MANANTALI DAM

NOTE N° 27
Rev. A.

REPORT ON THE DAMAGE
TO THE RIP-RAP

DEFINITION OF THE WORKS
EXECUTION MODE AND SCHEDULE
COST ESTIMATE

Abb. 2
Erodierte Fläche in der Deckschicht (Prinzipische Skizze)

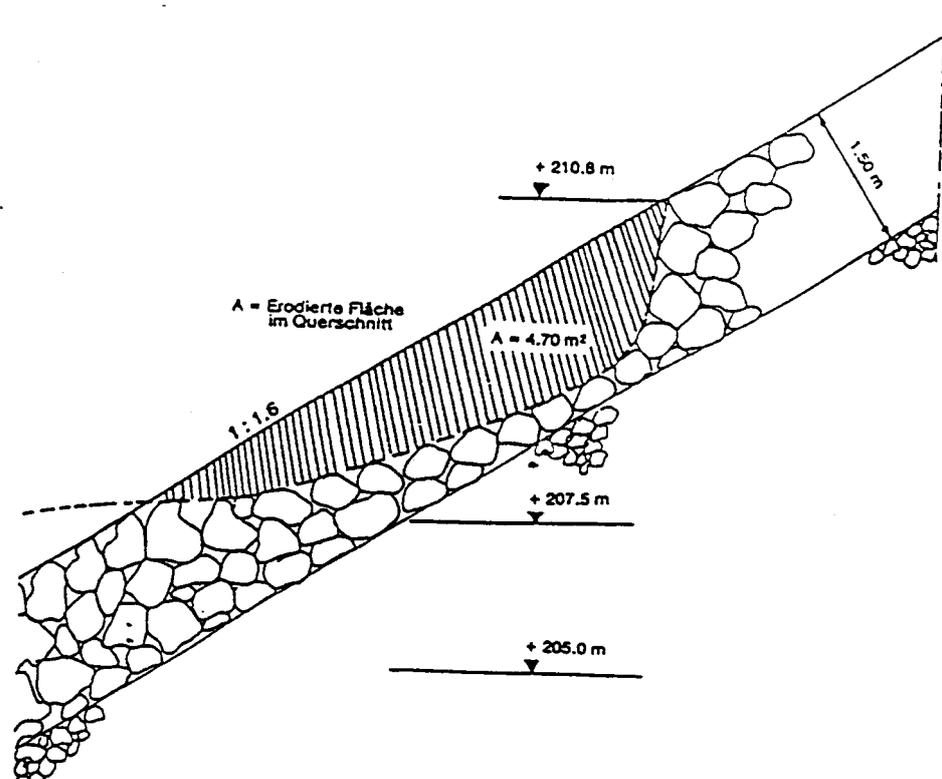
2.3 Die in (1), S. 8 angegebene Formel für die Ermittlung der erforderlichen Blockgewichte sollte heute nicht mehr in der dargestellten Art angewendet werden. Wird bei formal gleichem Aufbau der Formel mit den heute anerkannten Parametern gerechnet (aktualisierte HUDSON-Formel, s. Pkt. 5 mit den Parametern $a = 3$ - damit wird die Formel dimensionsrein - und $K_{RR} = 2,5$), so ergibt sich für das erforderliche Blockgewicht W_{50} statt des in (1), S. 10 errechneten Wertes von 180 kg bei Ansatz gleicher Wellenhöhe (1,4 m) ein Gewicht von rd. 420 kg, entsprechend einem $D_{50} = 0,55$ m mit $D_{\max} = 1,6 \cdot D_{50} = 0,88$ m und $D_{\min} = 0,5 \cdot D_{50} = 0,28$ m.

In diesem Zusammenhang ist anzumerken, daß nicht schlüssig nachzuvollziehen ist, wie aus einem Blockgewicht von 180 kg die Durchmesser 380 mm bis 580 mm entwickelt wurden (1, S. 10), die den Spezifikationen des Bauvertrages zugrunde gelegt wurden. Die Angabe 580 mm ist übrigens in der Sieblinie in (1), S. 14, Fig. 4.6-1 nicht genau wiederzufinden, hier schneidet die rechts begrenzte Sieblinie die 50 %-Linie bei etwa 530 mm.

SOLUTION 1

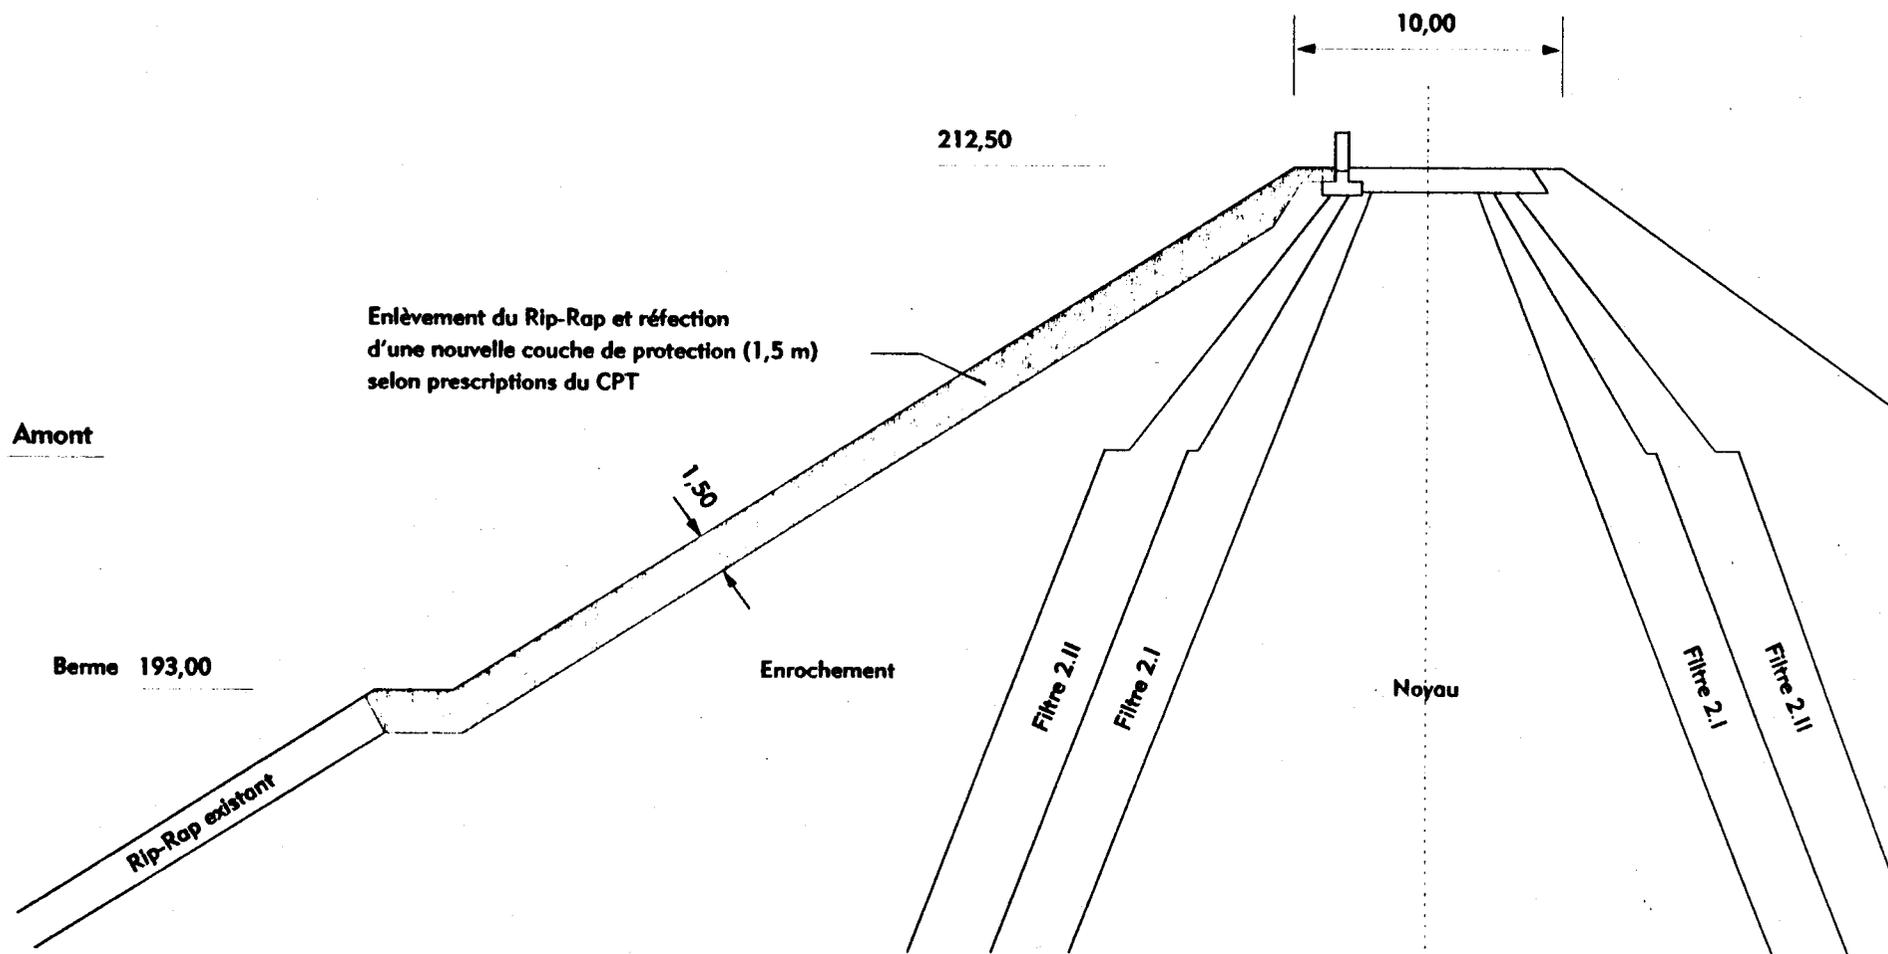
Solution 1 - rip-rap according to the CPT

This solution had been recommended by the Engineer in report n° 26.

It consists of the total removal of the existing rip-rap from the crest down to the berm at level 193 m IGN, and then re-building a new rip-rap from the bottom up to the crest of the embankment according to the granulometry and execution rules of the CPT.

This solution is technically feasible and its execution calls for the same equipment as the other rip-rap reconstitution solutions.

However, this solution does not take into account recent research and experience in the field of breakwater construction at the sea. Besides, taking into account the additional cost of this solution in comparison with a repair which does take recent progress into account, this solution must be discarded.

SOLUTION 2a

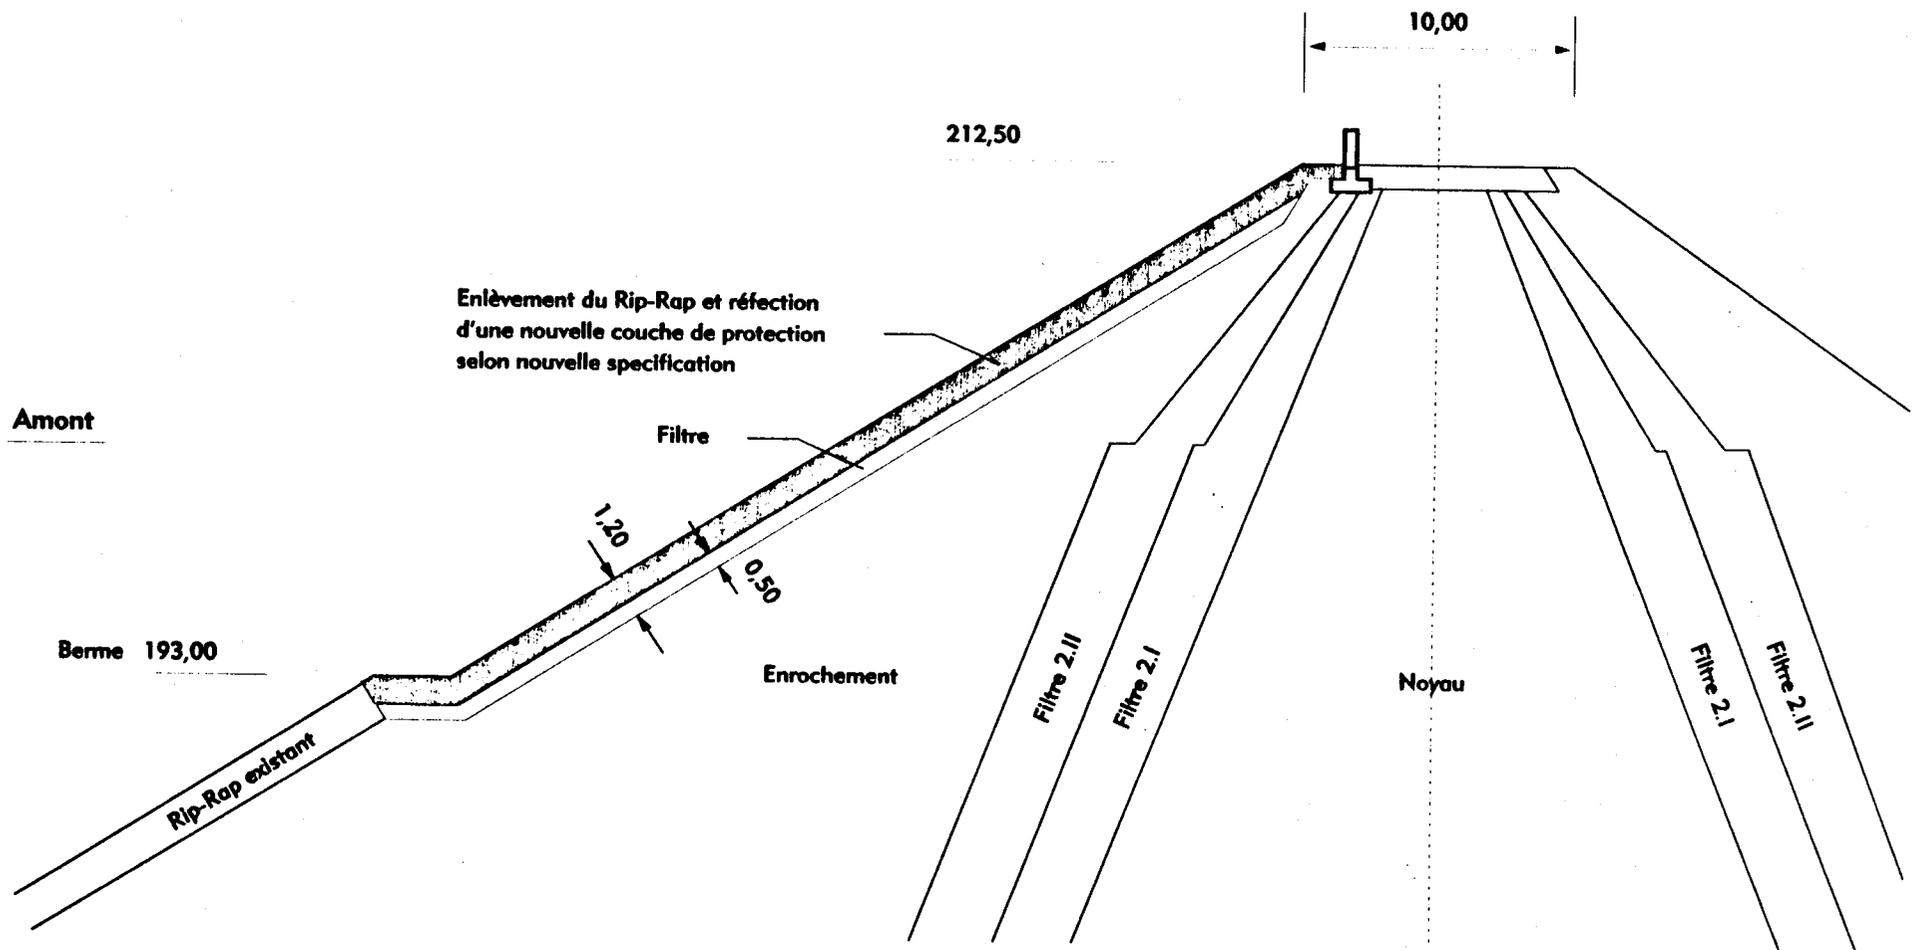
Solution 2 - "modern" rip-rap

This solution is an update or adaptation of solution 1. Indeed, it consists of the total removal of the existing rip-rap where this does not meet CPT specifications between the crest of the embankment and the berm at level 193 m IGN. The new rip-rap would be made up of larger blocks bedded on a filter 50 cm thick.

The granulometry of the new rip-rap would take into account the results of recent experiments and research in the field sea-shore construction of breakwaters and is thus a more "modern" than solution 1.

This solution is technically feasible. Its execution has been described in detail in the present note n° 27. The execution of this solution calls for equipment identical to that needed for solutions 1 to 2c.

Taking into account the relatively high cost of this solution, two alternative solutions, 2b and 2c, have been studied in order to reduce the volume of work by whatever extent possible and to derive maximum advantage from the increased size of the blocks.

SOLUTION 2b

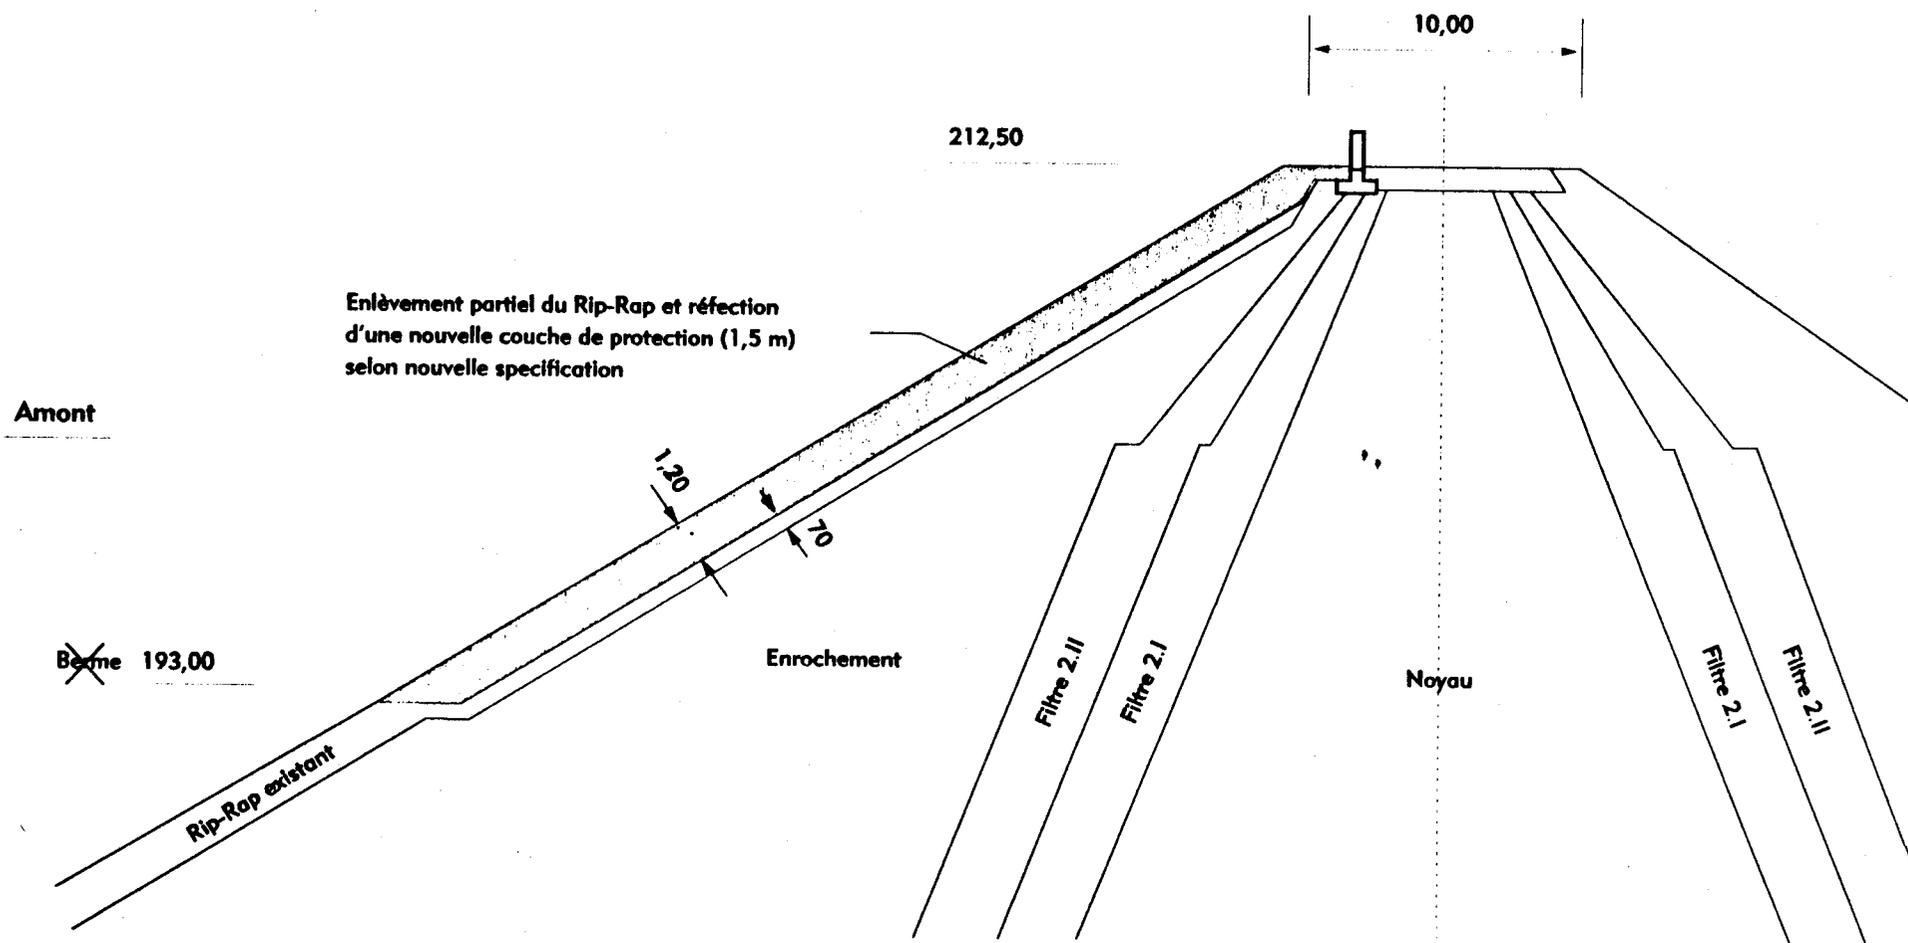
- Solution 2b

Instead of removing the existing and out-of-specification rip-rap entirely, only the top 70 to 80 cm of thickness would be removed. The remainder would serve as a filter for the new rip-rap.

For this 2b alternative, the cost of removing the rip-rap would be decreased by 50 % in comparison with solution 2a, whilst the cost of preparing and placing a filter would be completely eliminated.

The thickness of the rip-rap would be 1.50 m as in 2a.

SOLUTION 2c

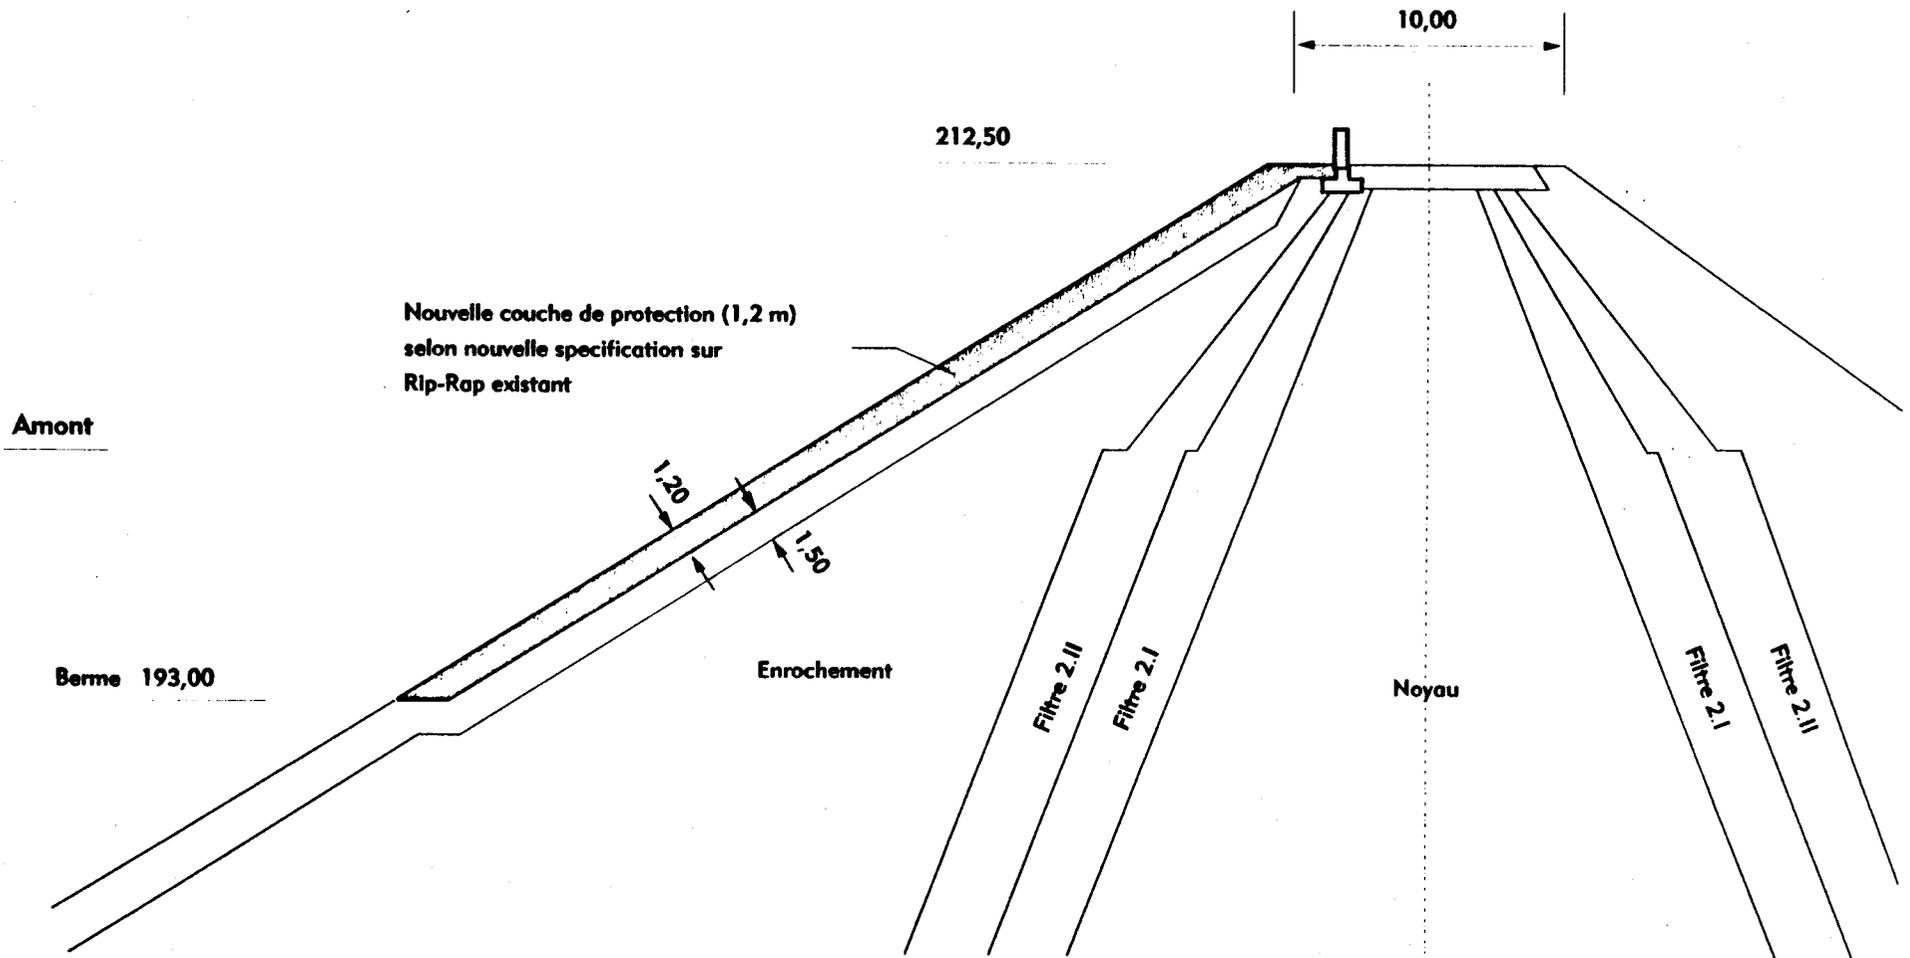
- Solution 2c

Provided that confirmation is received that the granulometry of the existing rip-rap meets the requirements for the new filter and that, at the same time, the existing path at level 193 is wide enough (berm = or > 2.50 m), it will be possible to retain this rip-rap. It will act as a filter with respect to the new rip-rap which will be 1.20 m thick. This technically satisfactory solution is by far the least expensive.

Solution 2c, the cheapest, nevertheless implies that the berm existing at level 193 is wide enough to serve as the support for the new rip-rap.

SOLUTION 3

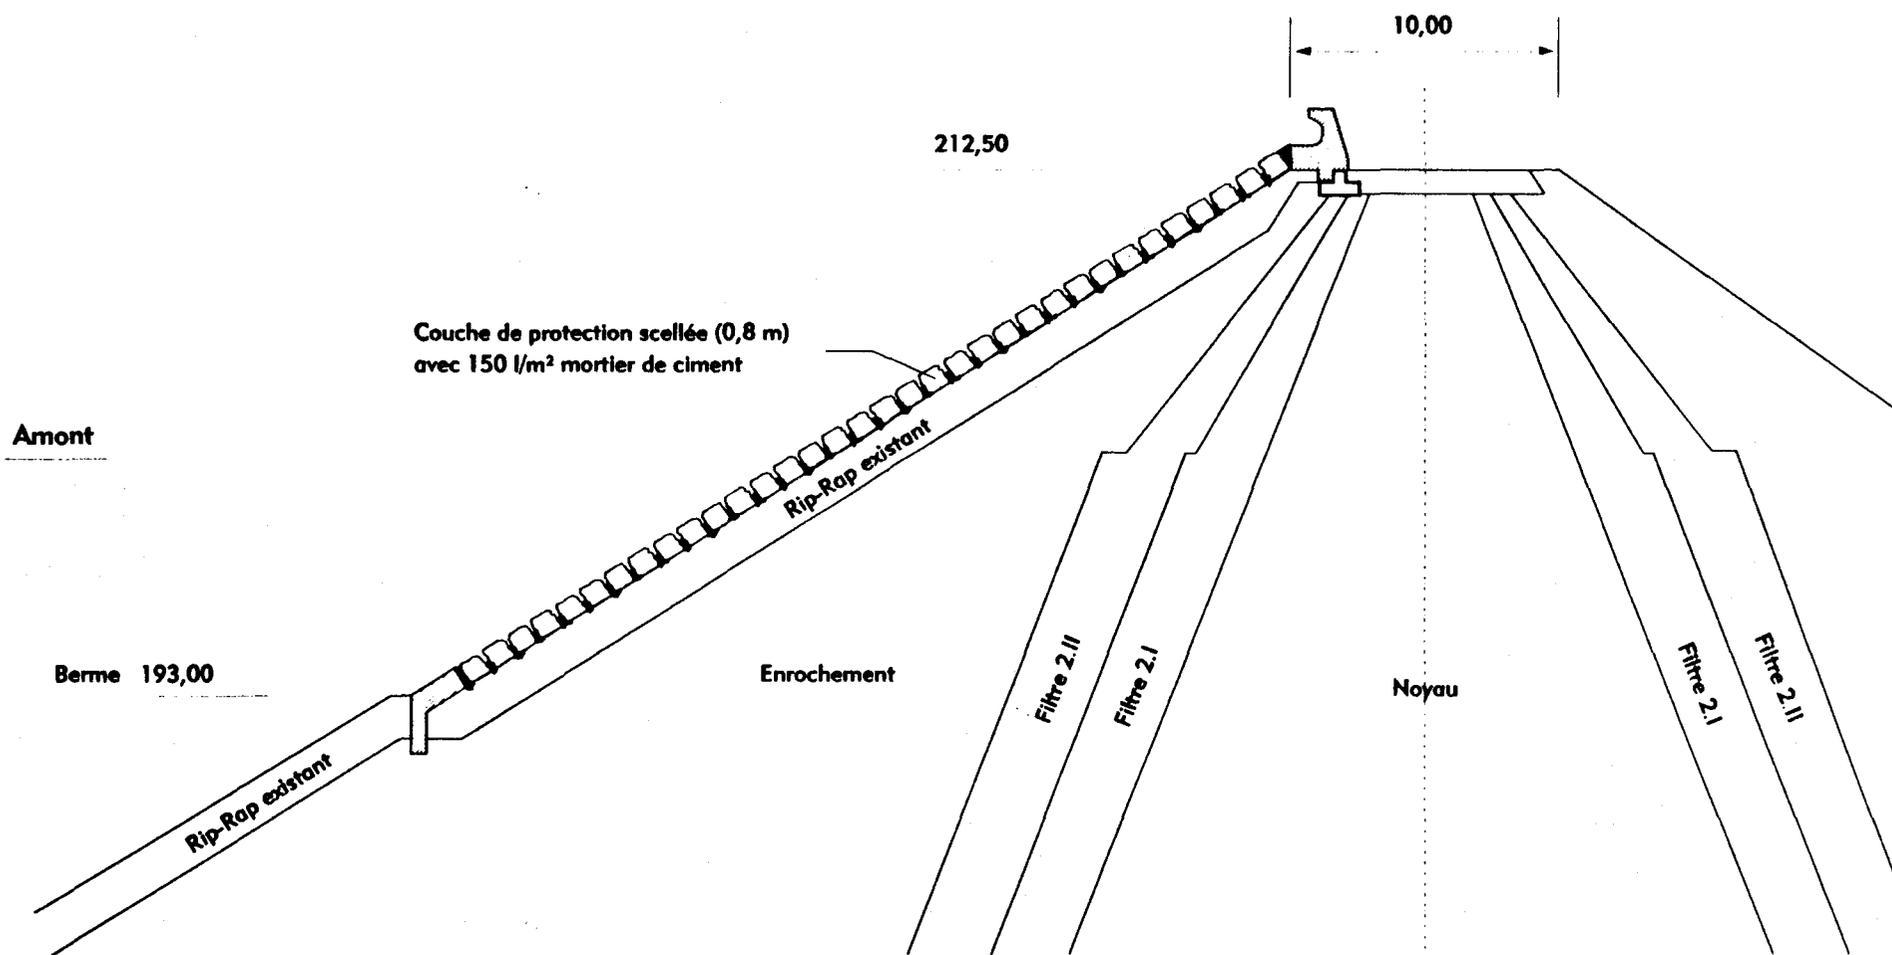
Solution 3 - Bedded rock blocks

This solution is not included in the rip-rap solutions but consists of placing rock blocks of 80 cm a side on the equalised surface of the existing rip-rap. It would be supported on a concrete base at level 193 m. To avoid dislocations under storm conditions, the blocks would be welded together by means of a special mortar. This special mortar would only surround part of the circumference of a block so as to maintain good permeability with the underlying filter layer, made up of the existing rip-rap.

This solution is tempting to the extent that it could be executed on the surface of the existing rip-rap without any removal.

However, although technically feasible, it comprises the risk of considerable damage if the surface of the embankment were to be even slightly damaged. It would therefore call for extremely careful maintenance whilst retaining this non-negligible risk.

For this reason, we propose to discard this solution.
